DESCRIPTIVE REPORT

Registry No. H12441

Sublocality North of Avatanak Island

Revisions and Corrections Performed During Office Processing and Certification

Figure 10 Contours and Charted Soundings to be Modified in the ENC and RNC

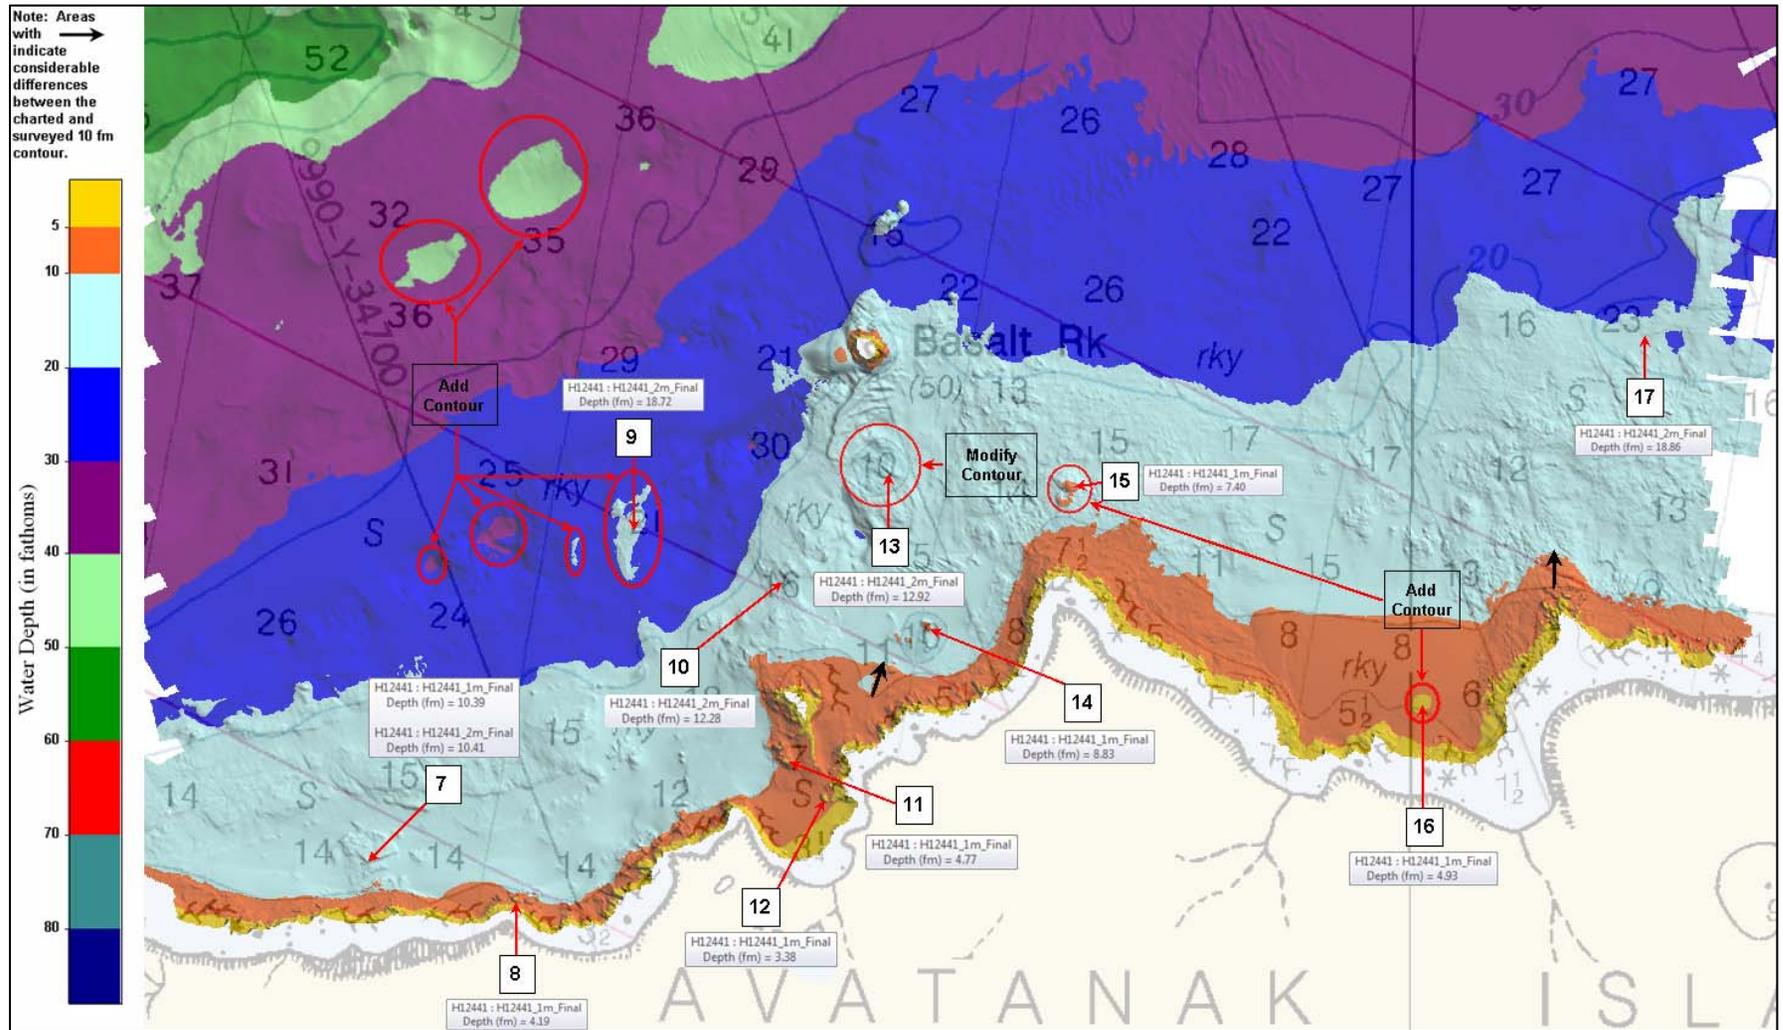
⁹ Depth curves included in the chart update product are based on contours generated from the Combined BASE Surface, generalized as suitable for compilation to the largest scale raster chart.

Figure 11 Proposed Modifications to Contours

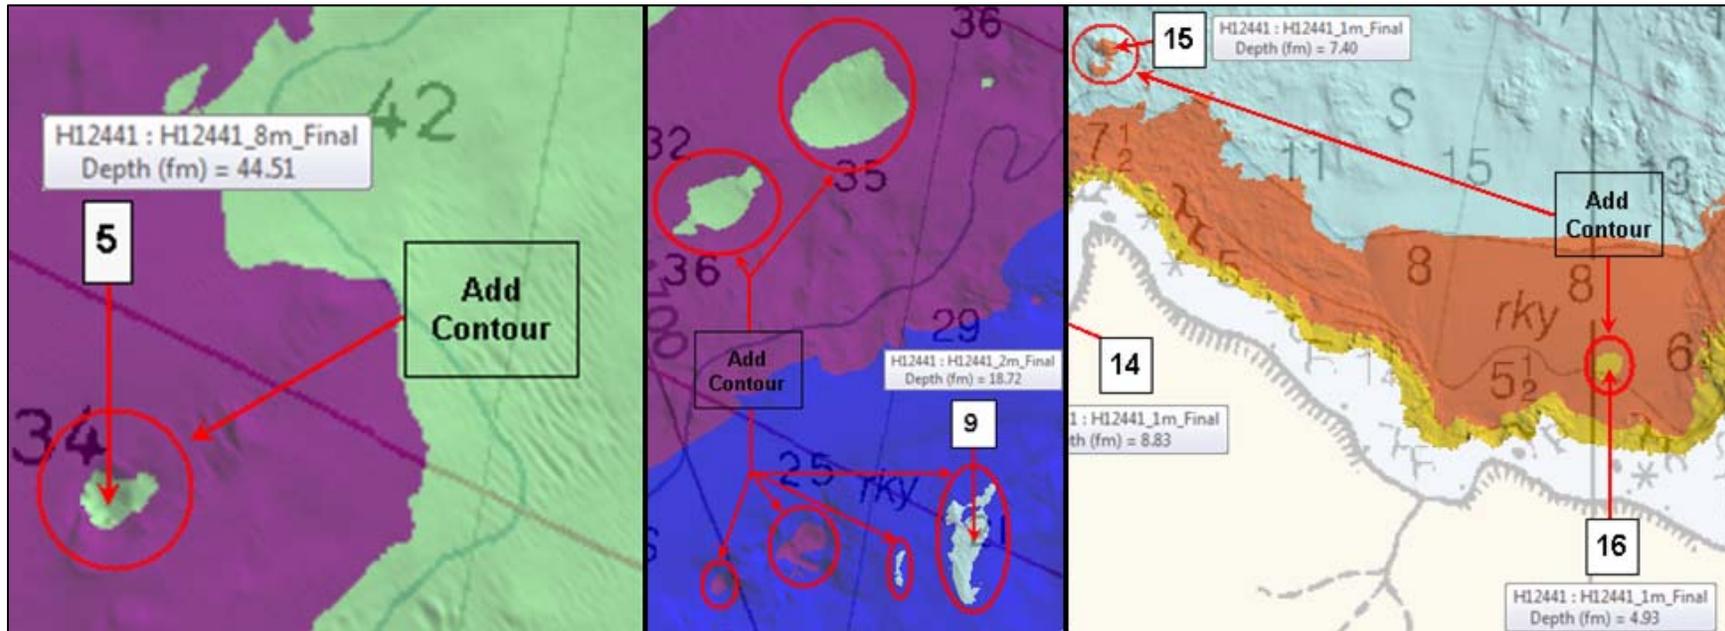
¹⁰ Contours for the chart update product are derived from the Combined BASE Surface. Final placement and complexity of depth curves are determined based on a number of factors, including soundings selected for compilation and the scale of the chart.

REPORT OF DANGERS TO NAVIGATION

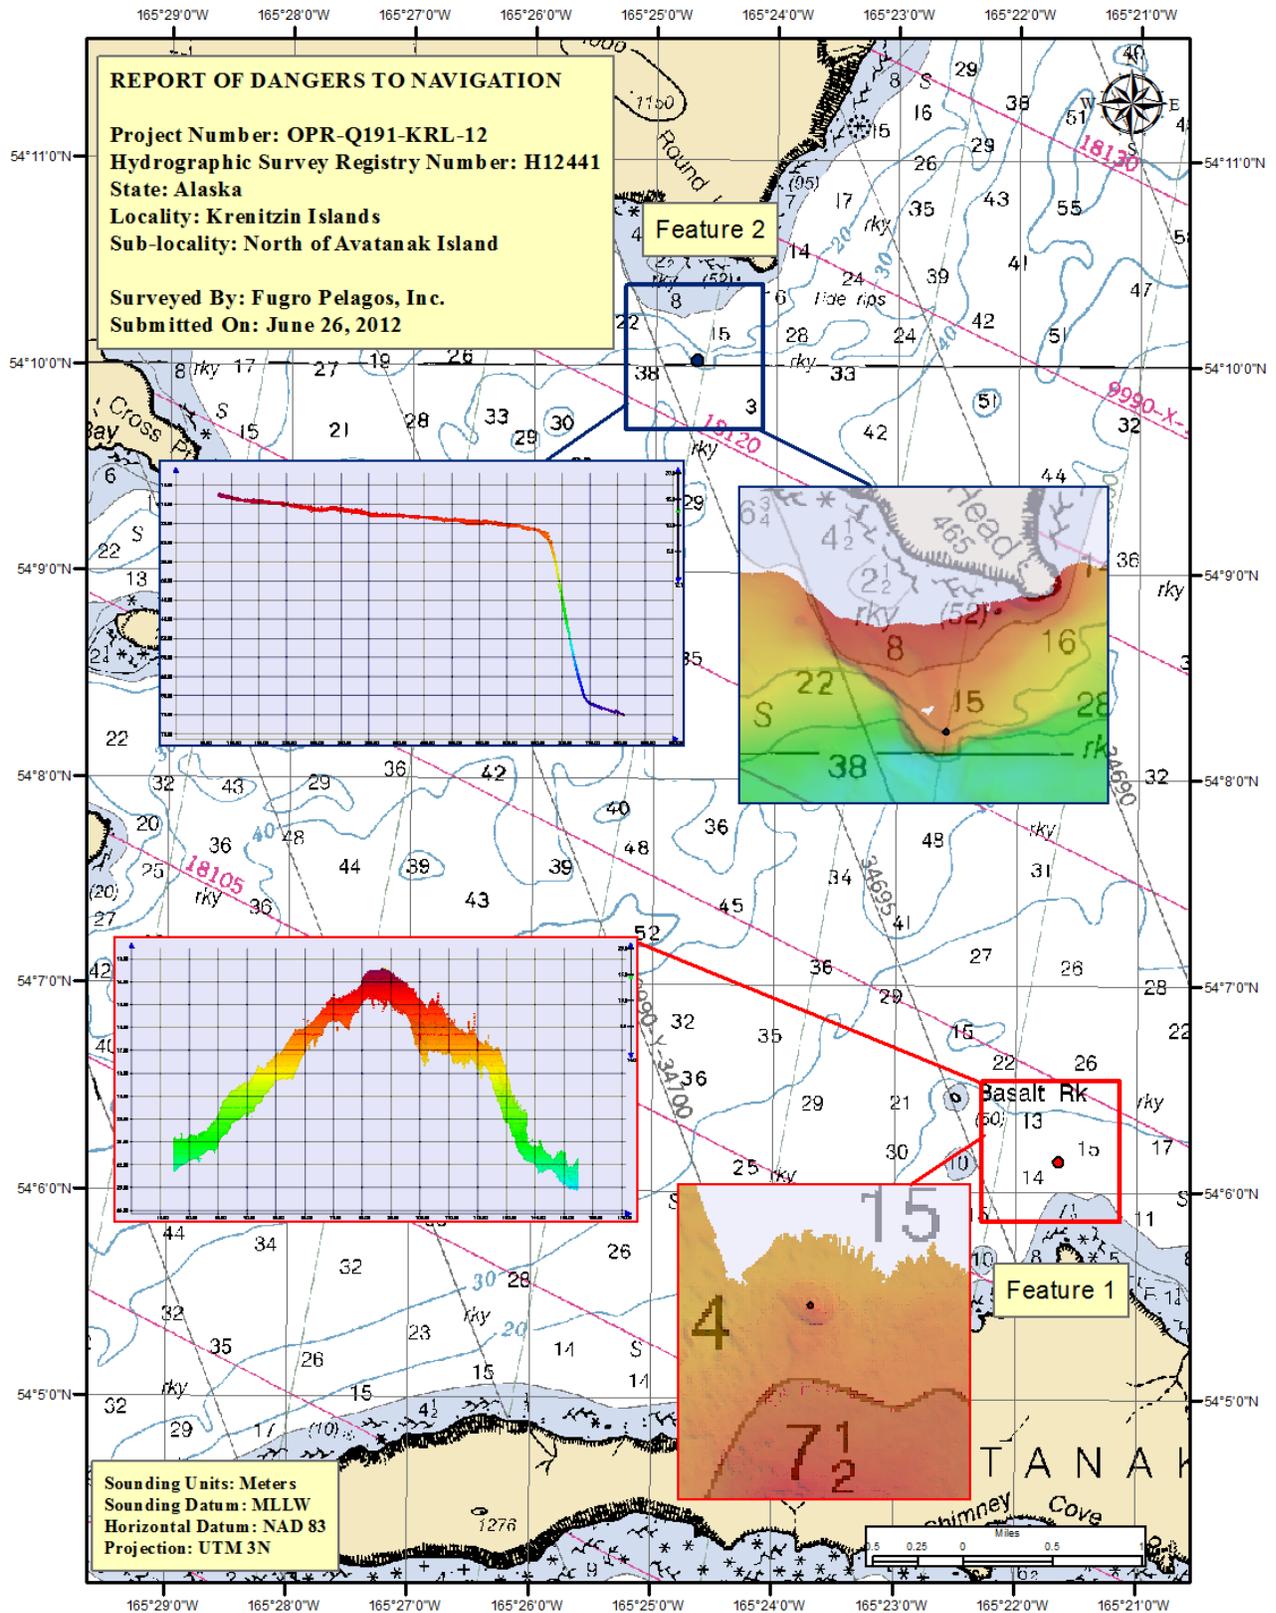
These two Dangers to Navigation were not submitted to Marine Chart Division for immediate compilation to the chart, but are reflected in the chart update product. DTON #1 was compiled to the chart update product as a 7fm 2ft sounding. The shoal given for DTON #2 is represented by a new 10fm depth curve.
